HISTORIC PRESERVATION COMMISSION

MEMORANDUM

SUBJECT: Historic Area Work Permit # 960431 - Driveway Replacement

Applicant: Julie Hewitt
Address: 4709 Piney Branch Rd., Takoma Park

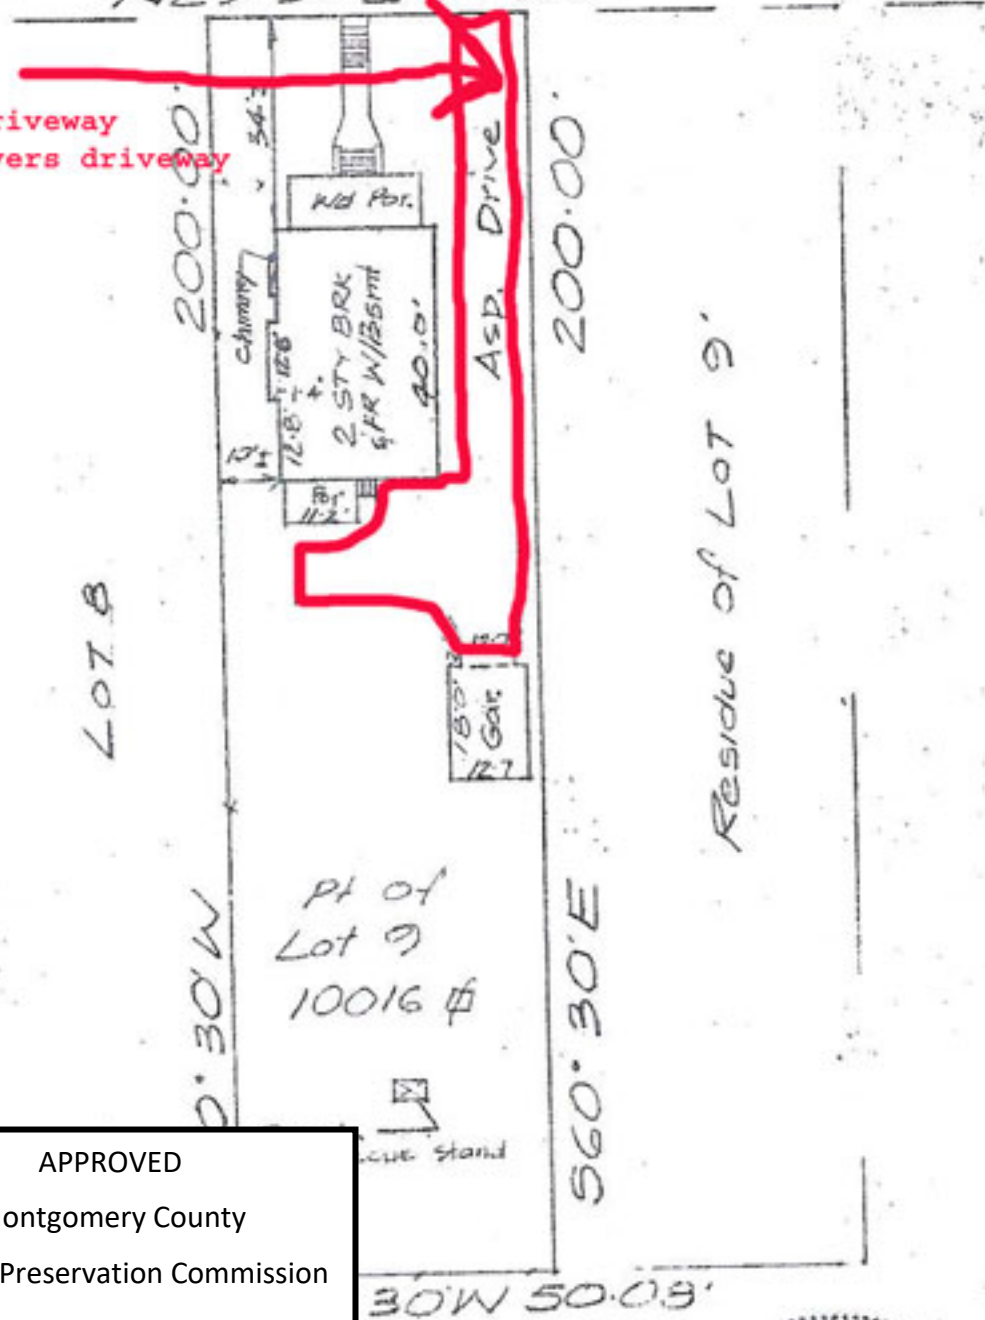
Replace asphalt driveway
with permeable pavers driveway
Same footprint

APPROVED
 Montgomery County
 Historic Preservation Commission
